first floor plan
(typical floor plan)

C	P	SENIOR ARCHITECT (SZ) I MADRAS
W	D	140, marshalls road, Egmore, madras 600008
		drg no: SA (SZ) I TD/10/62. SHEET 2
scale: 1/50		TYPE II load bearing
date: march '91		block of 6 qtrs (3 storeyed)
file no:		
dealt: janki		first floor plan.
subadh. chand	A. G. John	S. F. B. Jesudian
asst. architect	architect	sr. architect

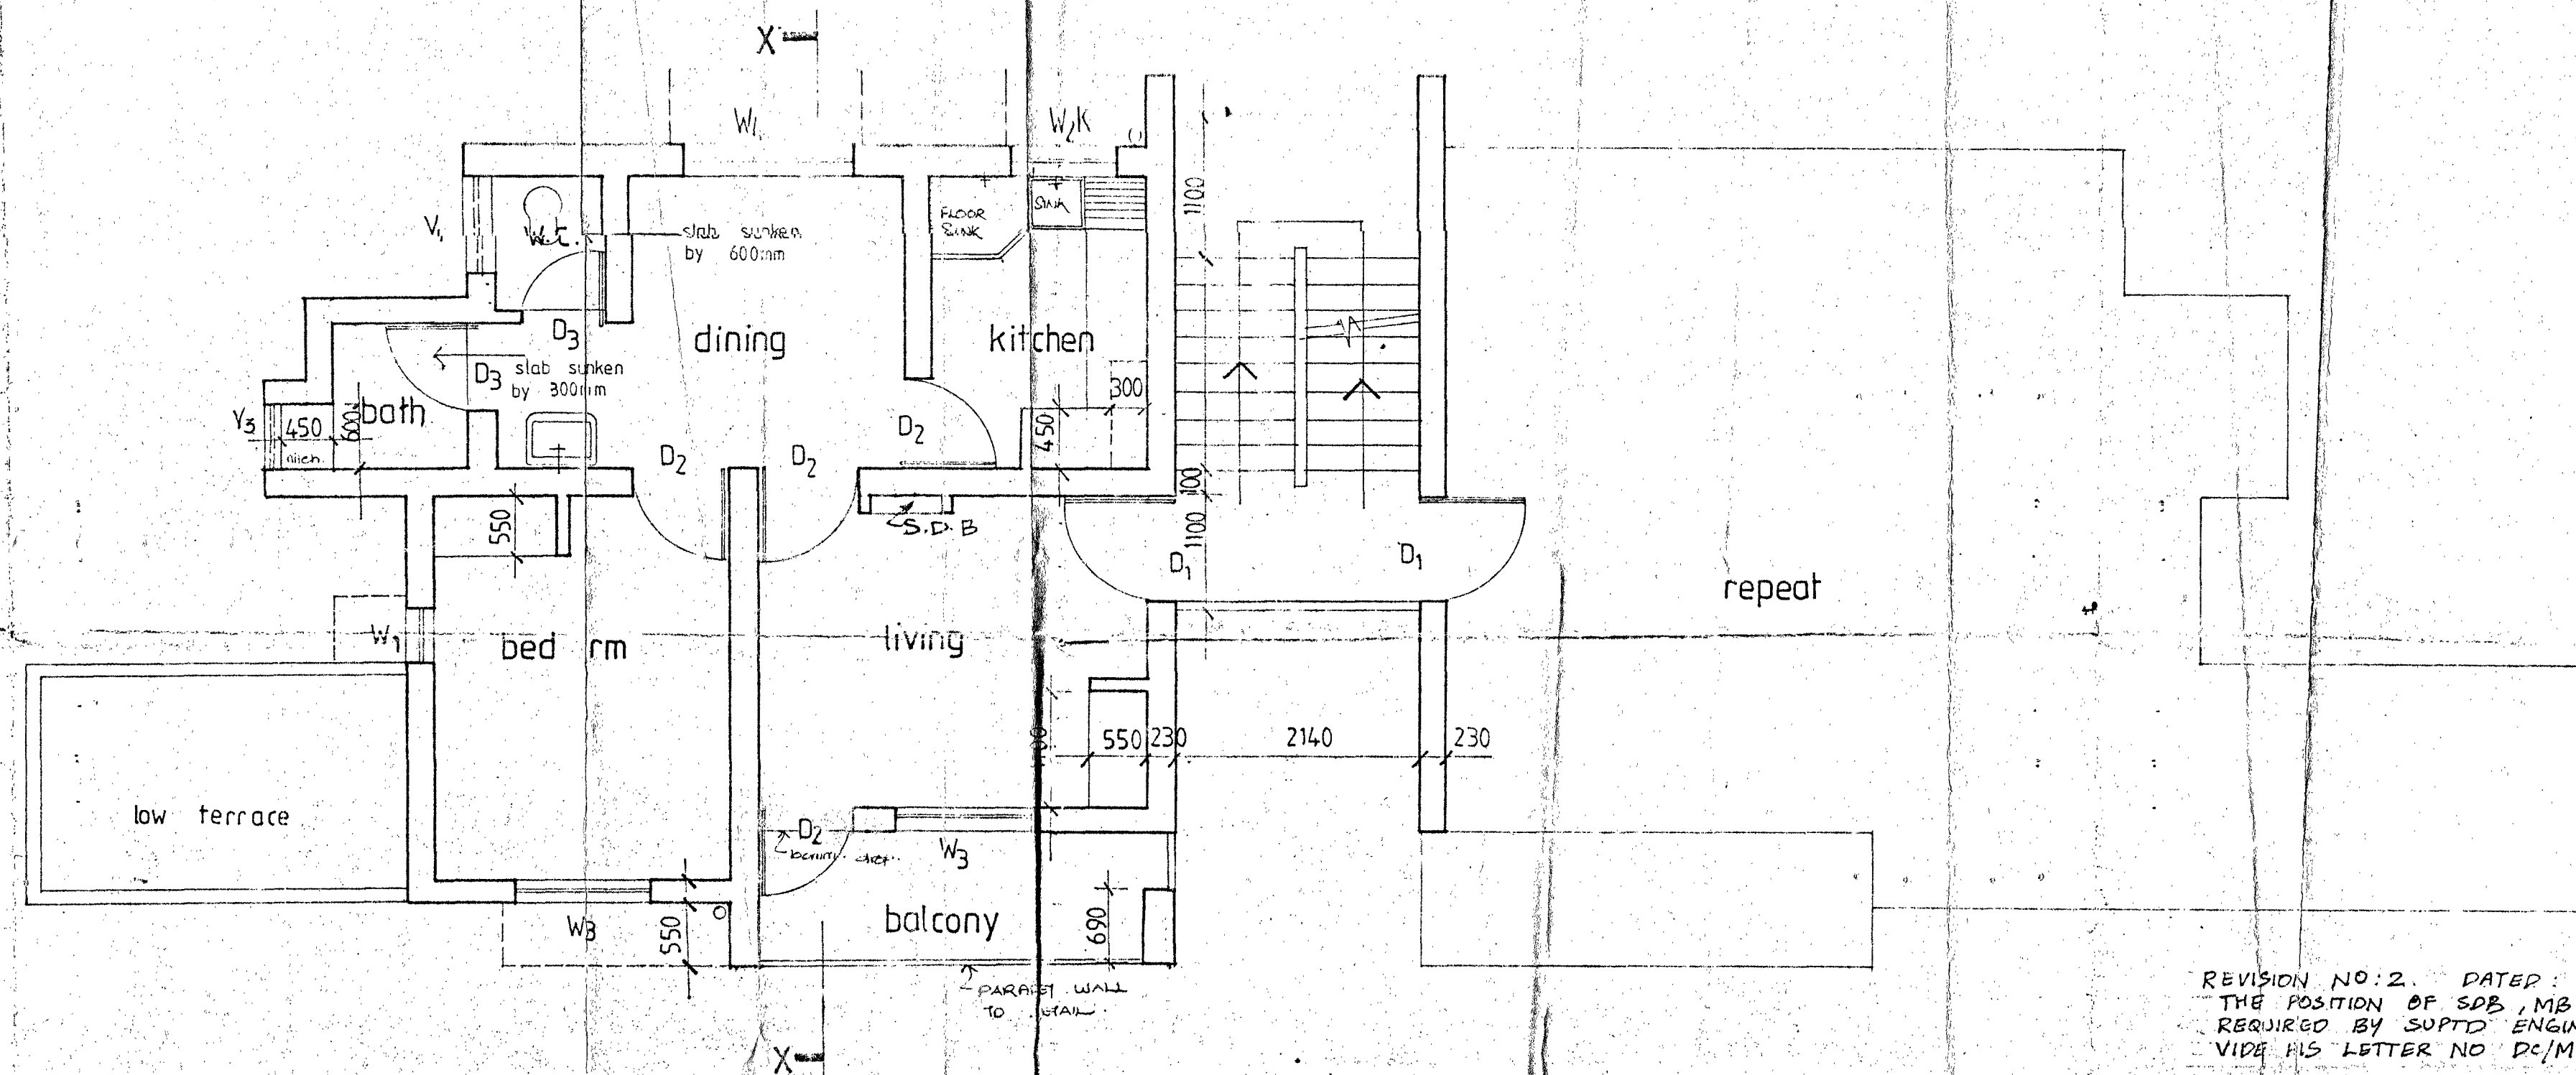
REVISION NO: 2. DATED: 19.8.91.
THE POSITION OF SDB, MB, HAS BEEN REVISED AS
REQUIRED BY SUPD ENGINEER, MADRAS CENTRAL CIRCLE
VIDE HIS LETTER NO DC/MCC/91/2964 DATED 27.7.91.

REVISION NO: 1. DATED: 19.8.91.
DRG NO: SA (SZ) I TD/10/62. CORR. 2. DATED: 19.8.91.
THE POSITION OF SDB, MB, HAS BEEN REVISED AS
REQUIRED BY SUPD ENGINEER, MADRAS CENTRAL CIRCLE
VIDE HIS LETTER NO DC/MCC/91/2964 DATED 27.7.91.
